ALERT SERVICE BULLETIN

ASB 210-24-19

SUBJECT: MAIN BEAM CAP ANGLE, P/N: 205-030-163-093,
INSPECTION OF.

Figure1. Fuselage Tailboom Attachment Inspection.

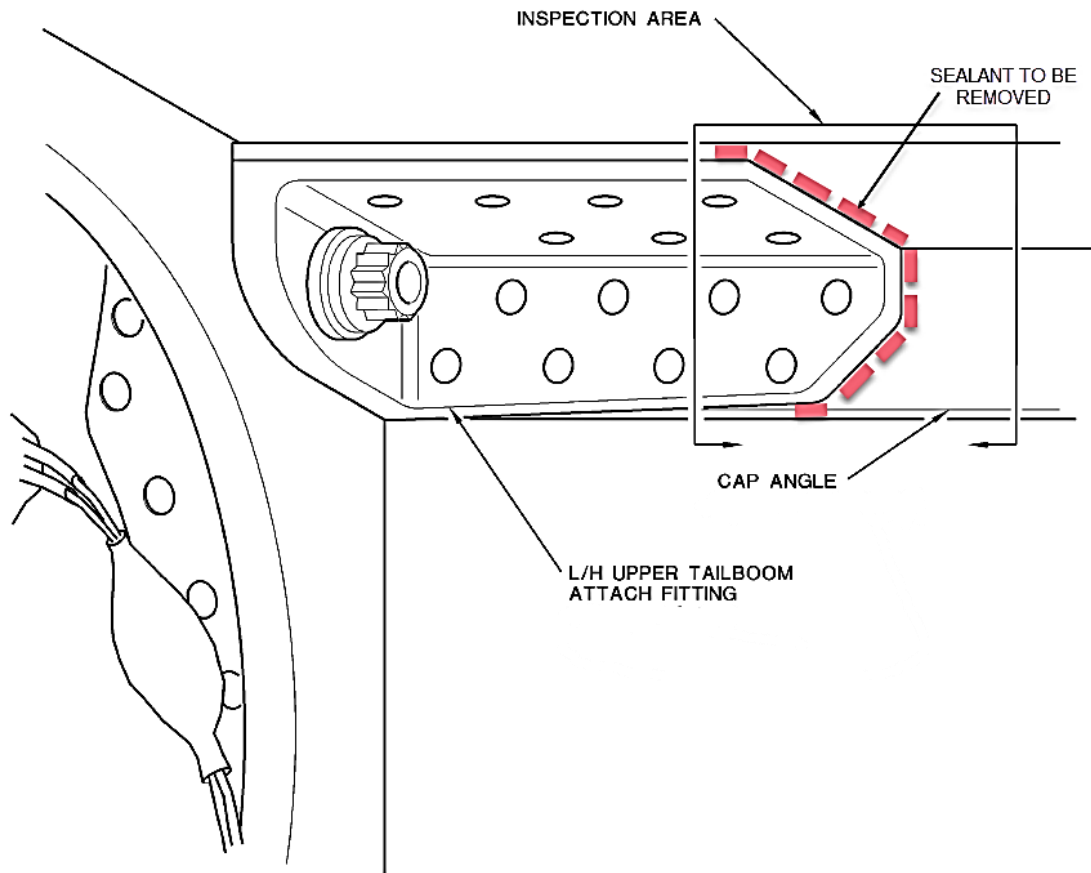
2. Remove sealant from edge of fitting (Refer to Figure 1).
3. Inspect the cap angle area shown in Figure 1 with a 10x magnifying glass and bright light.
4. If a crack is found, replace the cap angle before further flight. If no cracks are found, continue with Step 5.
5. Touch up primer and paint, if damaged during sealant removal, and allow to dry. Do not reapply sealant.
6. Ensure work areas are clean and secure. [QA]
7. Make an entry in the helicopter logbook and historical service records indicating findings and compliance with this Alert Service Bulletin.
